# DUKE POWER COMPANY

Re: Catawba Nuclear Station  
Docket Nos. 50-413 and 50-414

As a result of a meeting with the Reactor Systems Branch on June 28 and 29, 1982, Duke Power Company is transmitting herewith responses, revised responses, or partial responses to the following FSAR questions:

Figure 15.6.3-2  
Rev. 6

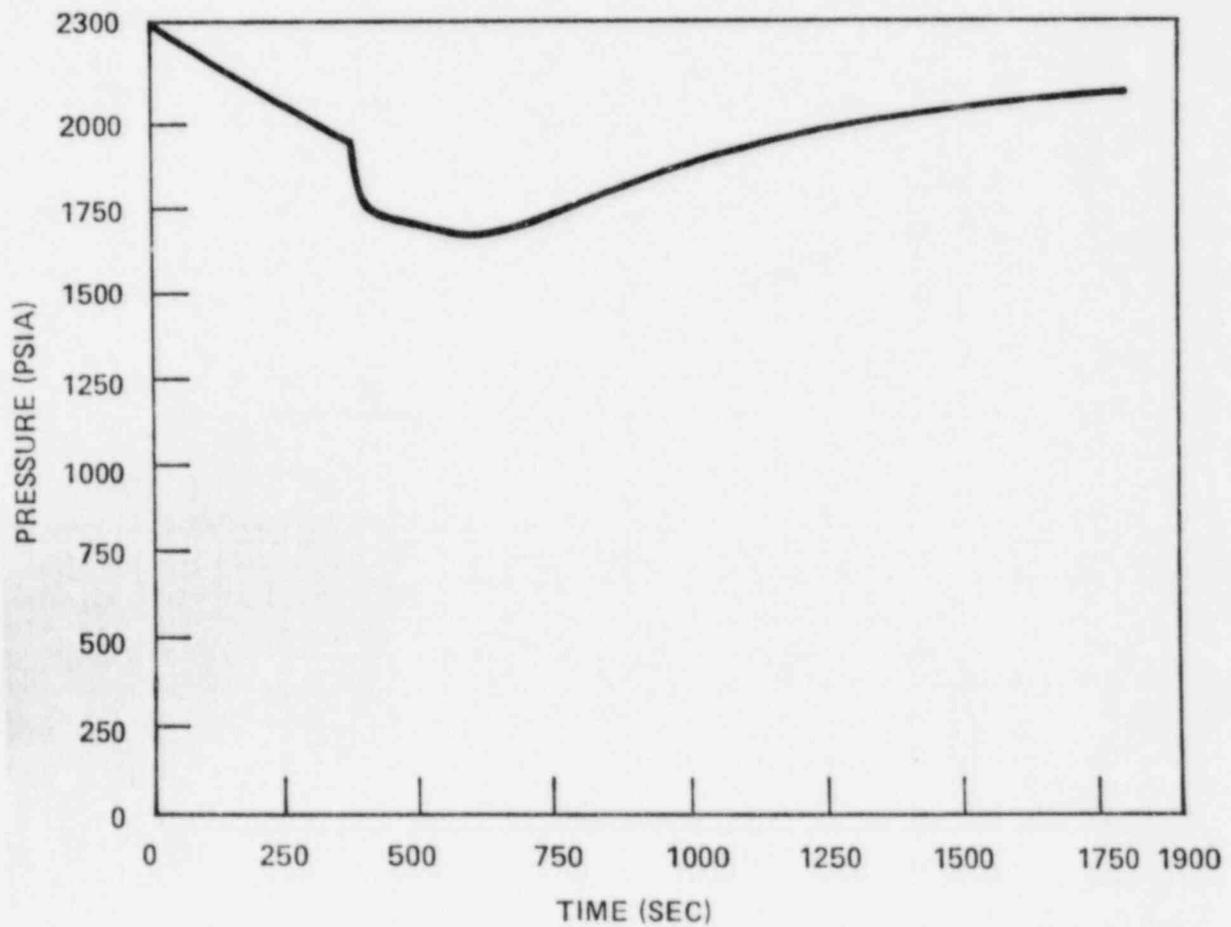
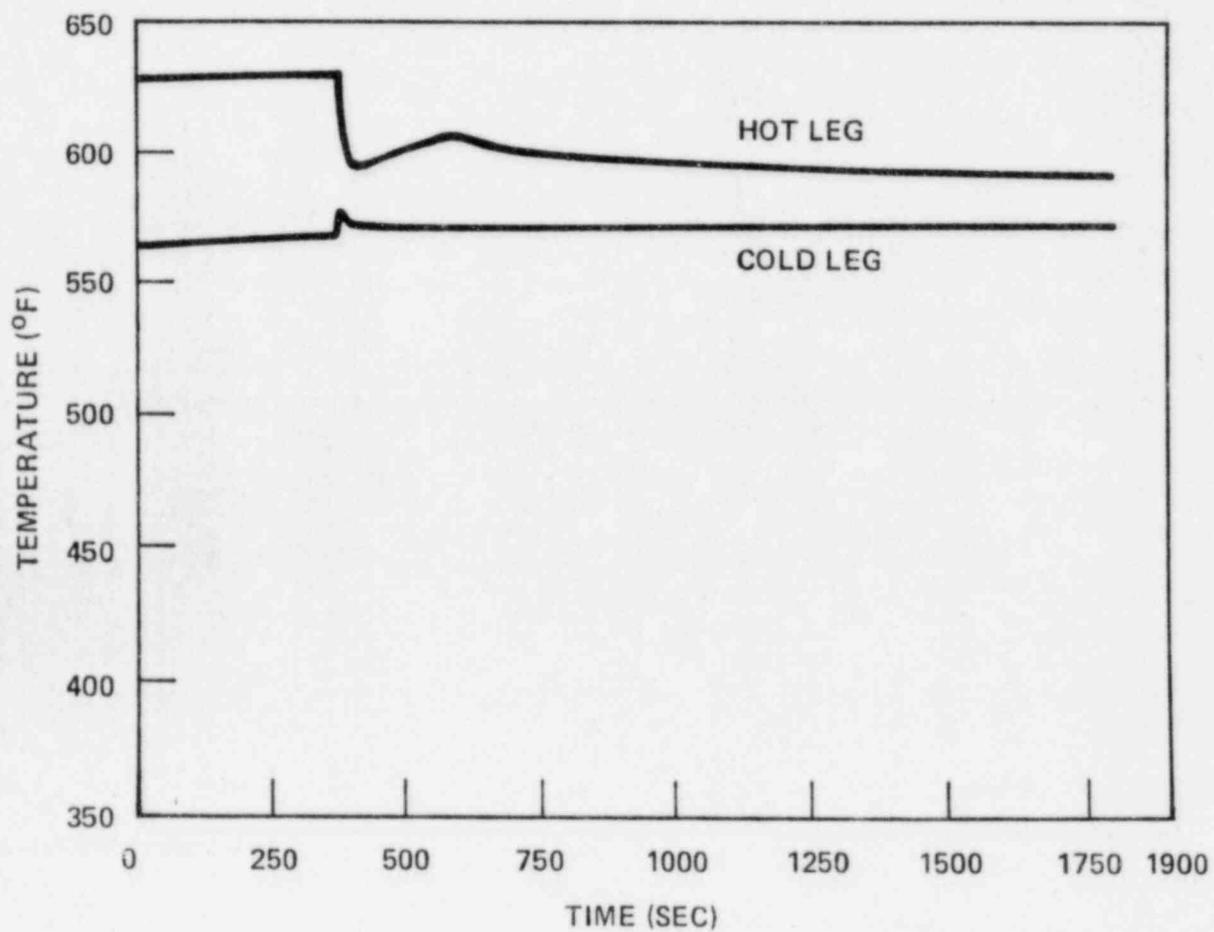
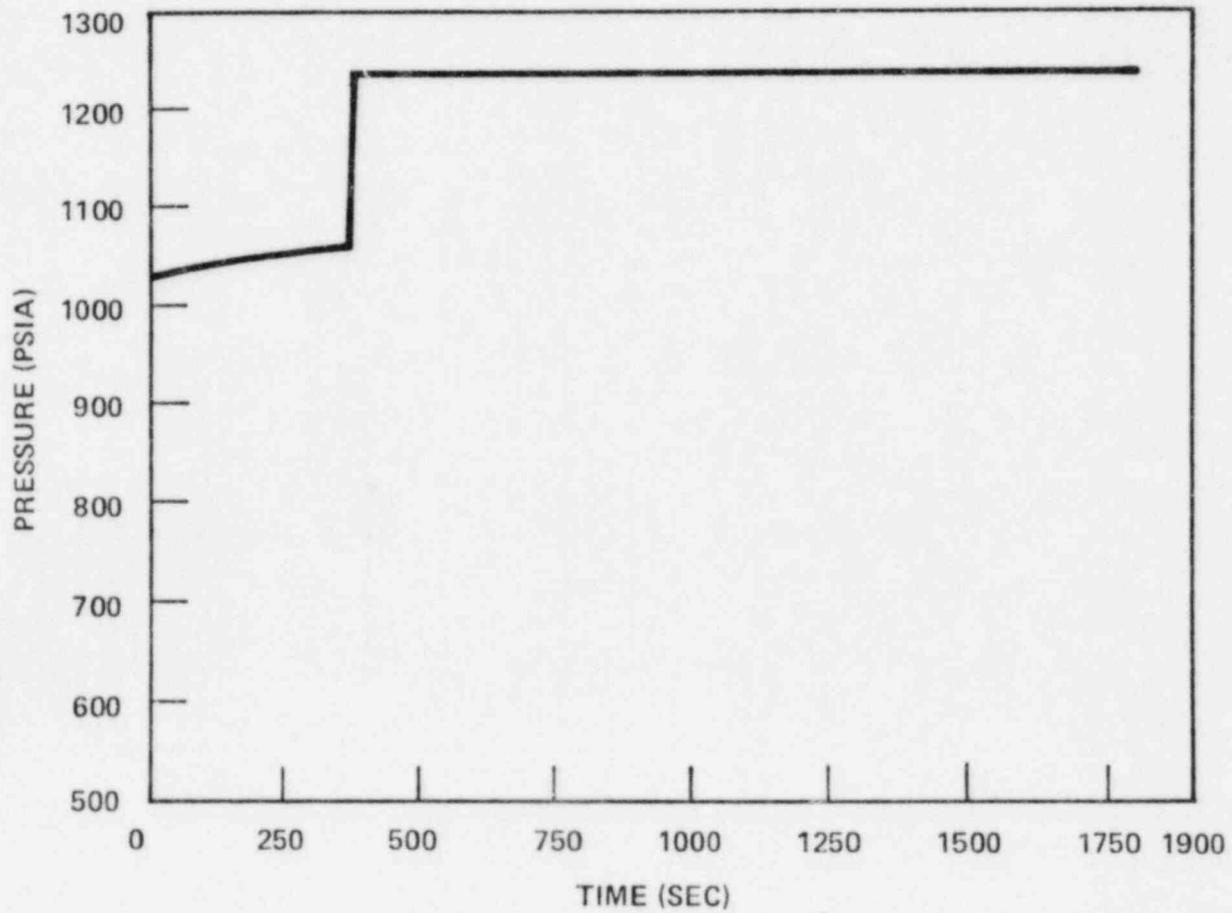
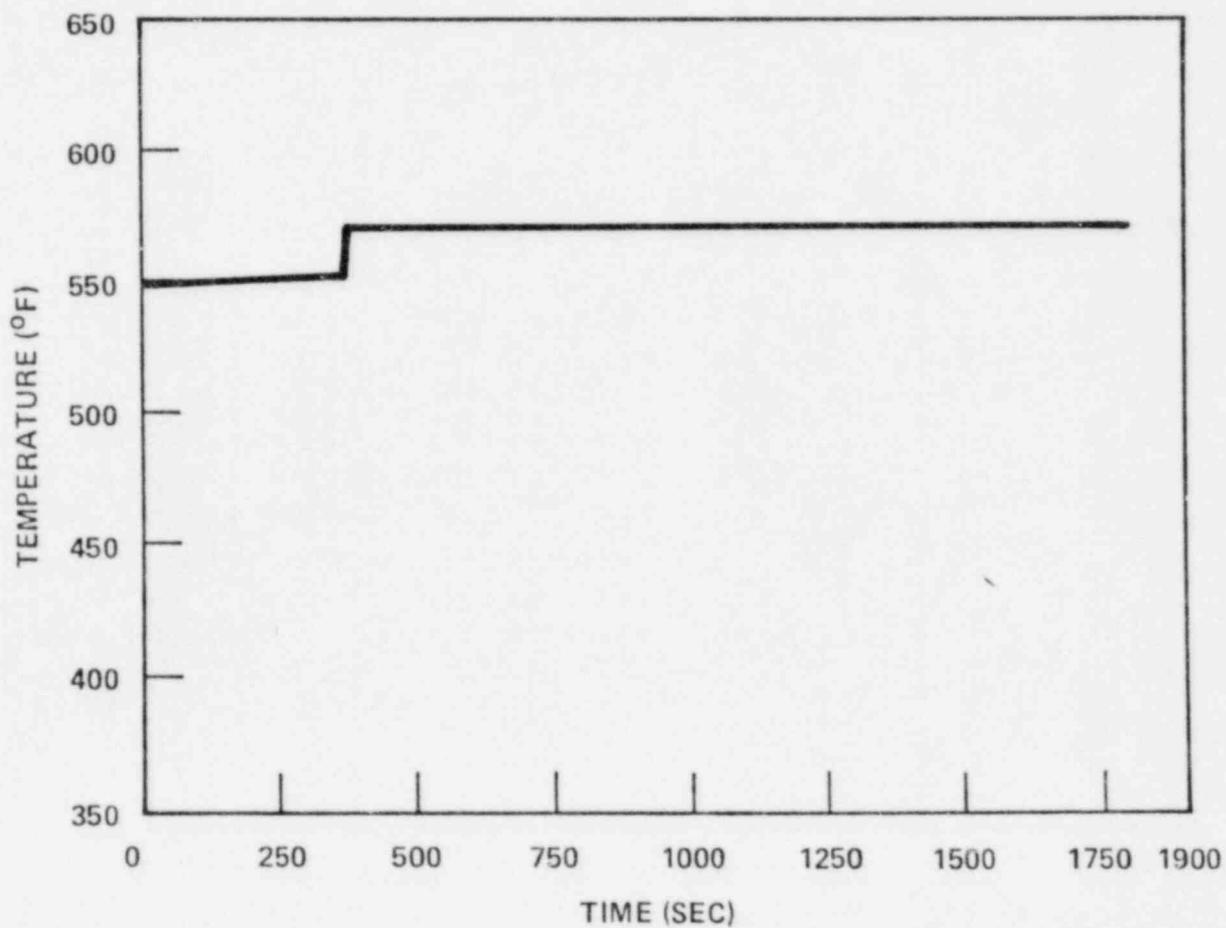
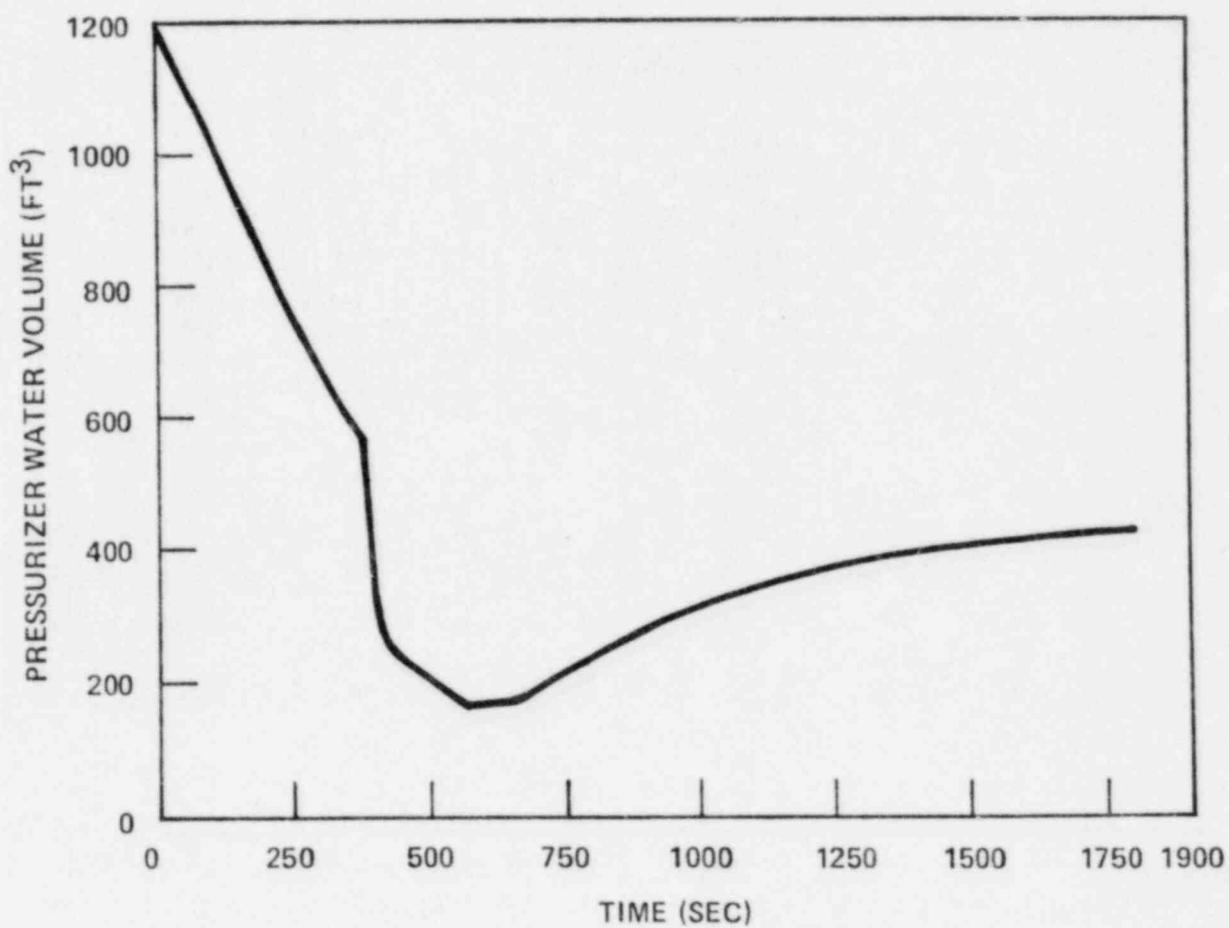
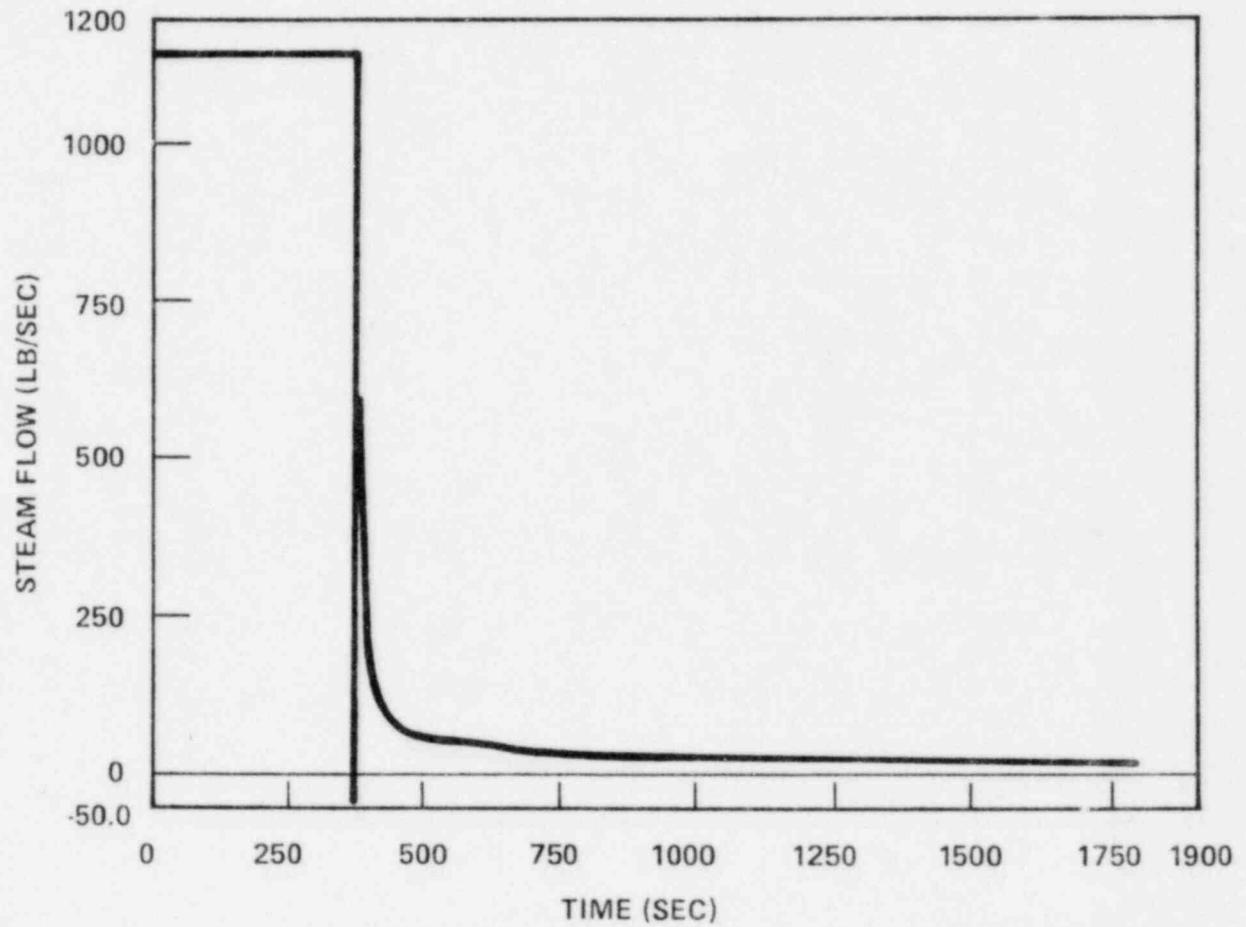
Your response to the steam generator tube rupture portion of Question 440.56 states: "Consideration of the indications provided at the control board, together with the magnitude of the break flow, leads to the conclusion that the isolation procedure can be completed within 30 minutes of accident initiation. Included in this 30 minute time period would be an allowance of 5 minutes to trip the reactor and actuate the safety injection system (automatic actions), 10 minutes to identify the accident as a steam generator tube rupture and 15 minutes to isolate the faulted steam generator." This scenario is not consistent with Table 15.6.3-1, Steam Generator Tube Rupture Sequence of Events, which states the safety injection signal occurs at 773.0 seconds. Evaluate this discrepancy and show that adequate time is available for completion of operator action at 1800 seconds as indicated in Table 15.6.3-1.

- Figure 15.6.3-2 Reactor Coolant System Pressure
- Figure 15.6.3-3 Reactor Coolant System Temperature
- Figure 15.6.3-4 Steam Generator Pressure (For Faulted Steam Generator)
- Figure 15.6.3-5 Steam Generator Temperature (For Faulted Steam Generator)
- Figure 15.6.3-6 Pressurizer Water Volume
- Figure 15.6.3-7 Steam Generator Flow

The response to Question No. 440.56 and FSAR Section 15.6.3 have been revised. Please refer to these revisions in response to this question.
